ARKANSAS
Department of Environmental Quality

RE: AFIN: 50-00062, Permit Tracking No.: 0323-WG-SW-1
S. W. Willisville SWD System

GENERAL PERMIT 0000-WG-SW INSPECTION FORM

S W Willisville SWD #3

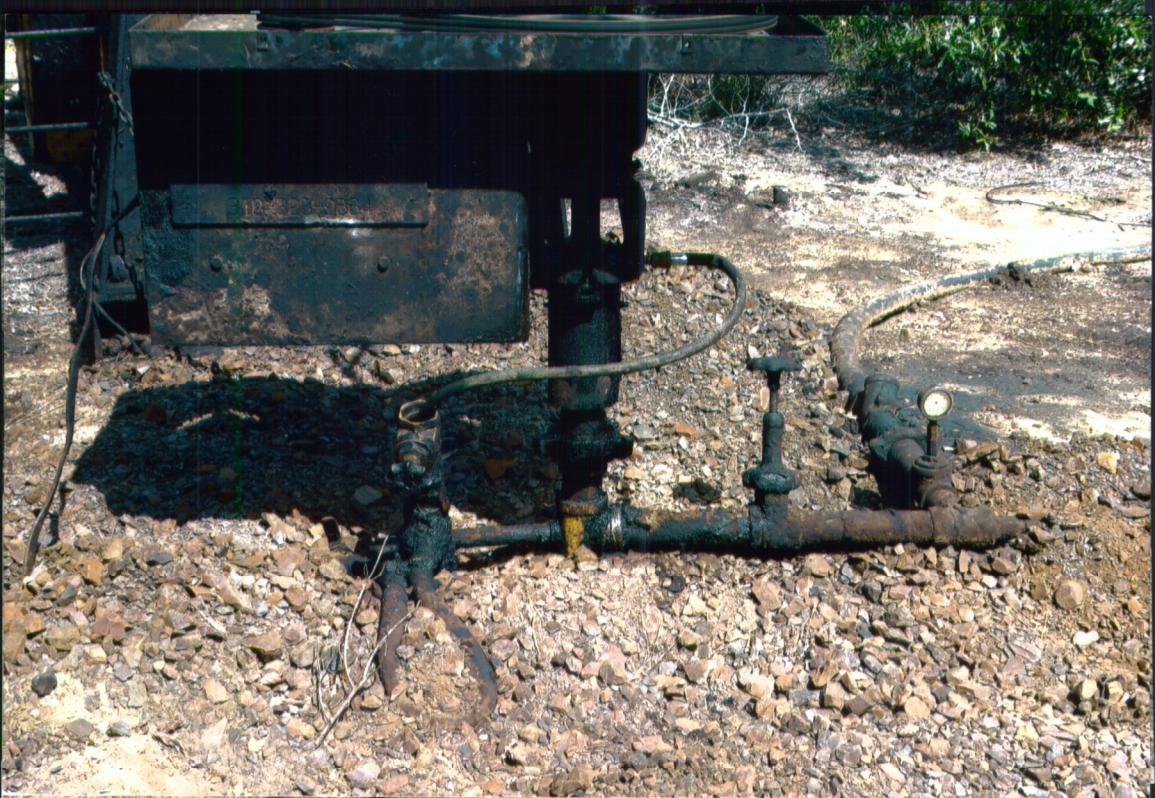
Description: System sign observed on the ground at the S. W. Willisville SWD No. 3 well site.

J A Alder Tank Battery
(Photo #6)

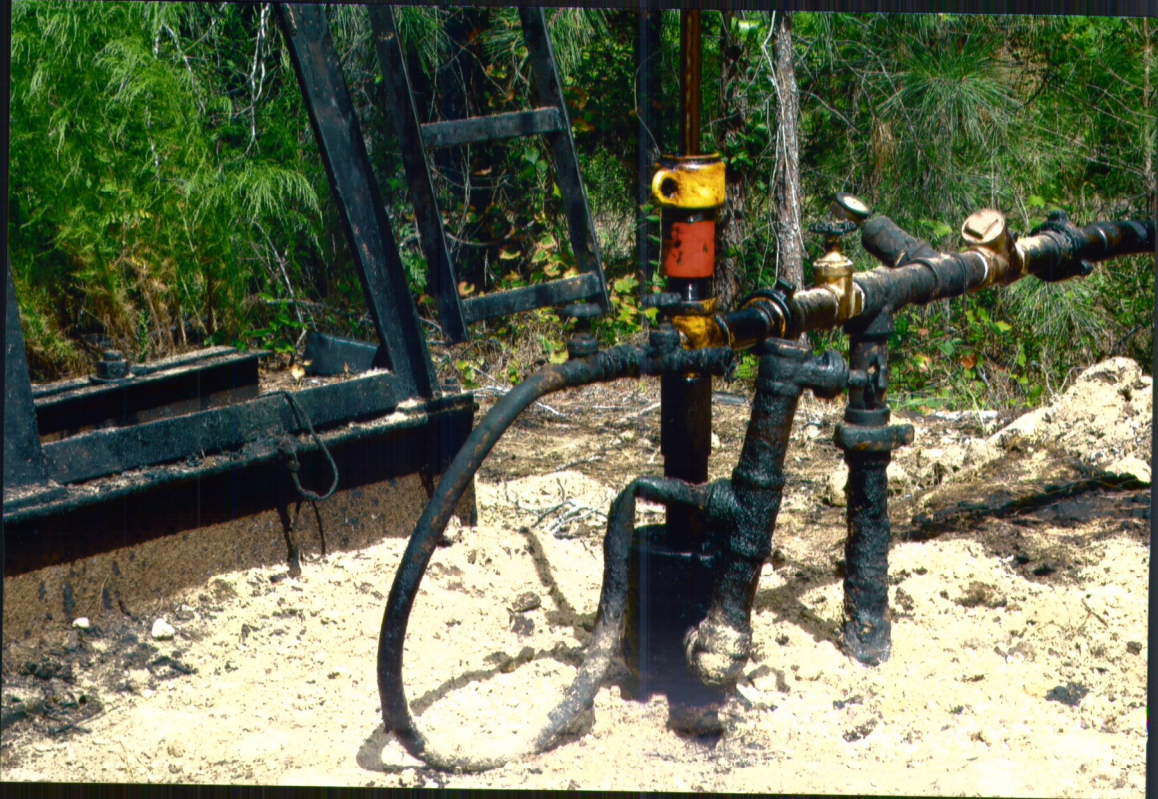
5. Oil waste observed inside the containment areas of the J. A. Alder Battery & S. W. Willisville No. 1 Saltwater Battery. See Photo Nos. 6 & 7. The operator is required to properly operate and maintain all parts of the system and may not place waste in a manner where it is likely to cause pollution of any waters of the state. This is a violation of Part III.B.7. of the general permit and Ark. Code Ann. § 8-4-217(a)(2).

Photographer: Connery Salter				Witness: None			
Photo No.	6	Of	18	Date:	8-10-11	Time:	1401
Description: Oil waste observed inside the containment area of the J. A. Alder Battery.

As you may recall, as you made your inspection, you ran across a crew of our employees already addressing many of the issues you documented in your letter to us. We have completed the "clean up" of our field operations which addressed all of the oil waste observed at the wellheads. We are hauling in clay to build up the three firewall berms that were mentioned in your letter. The oil waste within the J A Alder and S W Willisville firewalls has also been removed.

T E Ellis #5
(Photo #13)

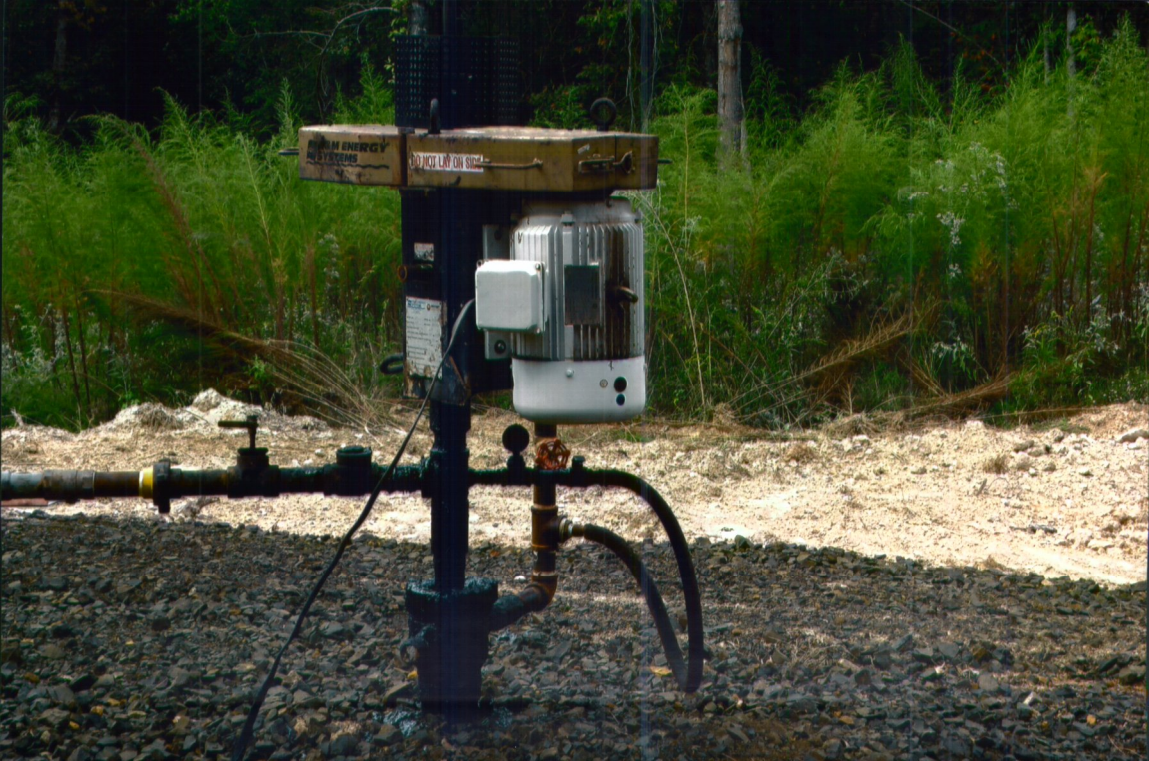
4. The T. E. Ellis No. 5 production well observed to be actively part of this system & is not listed on current permit. See Photo No. 13. Any change to the information previously submitted in an NOI requires submittal of a new NOI prior to the changes taking effect. This is a violation of Part III.A.1. of the general permit...

Description:	The T. E. Ellis No. 5 prod. well observed actively part of this system & not listed on permit.						
---------------------	------------------------------------------------------------------------------------------------	--	--	--	--	--	--

We are in the process of updating our permit to reflect some changes made and will be sending the changes to your office soon.

Phillips A TB

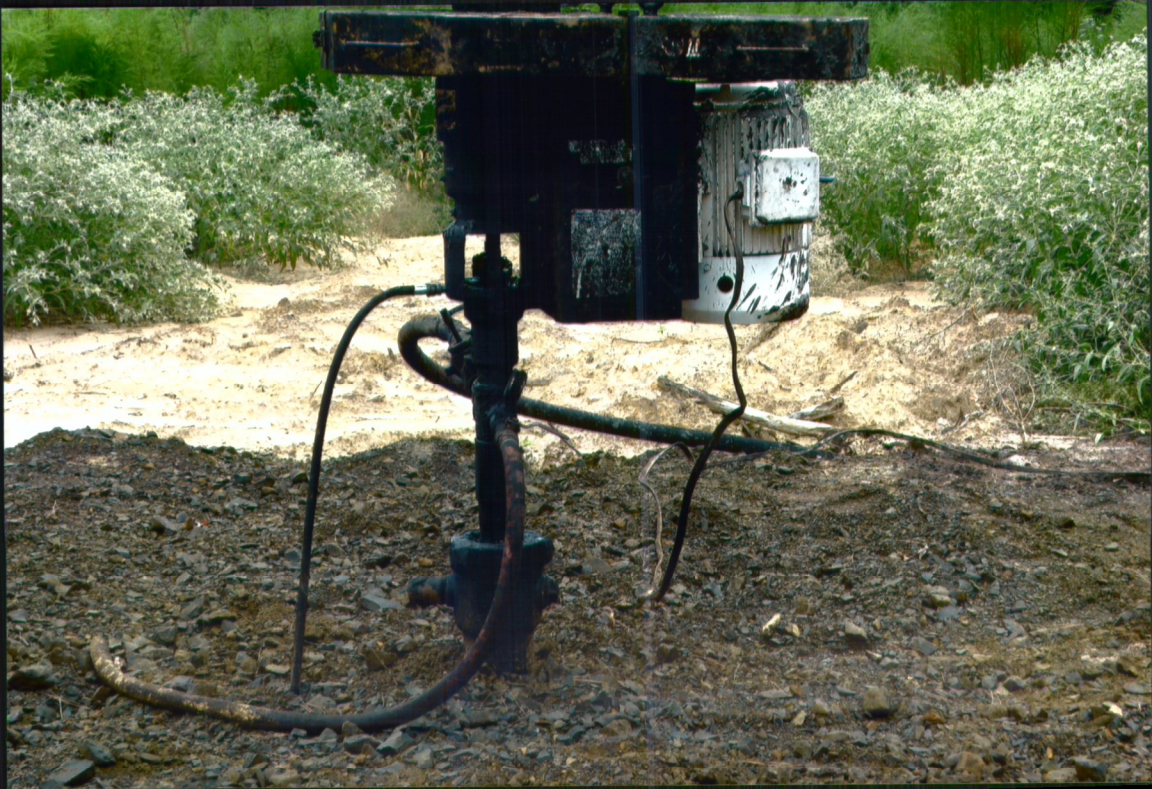
3. Firewall berms observed low at the Warmack-Montgomery, Phillips & Phillips A Batteries. See Photo Nos. 12, 16 & 18. Any change to the information previously submitted in an NOI requires submittal of a new NOI prior to the changes taking effect. This is a violation of Part III.A.1. of the general permit.

Description:	Firewall berm is low at the Phillips A Battery.						
---------------------	-------------------------------------------------	--	--	--	--	--	--
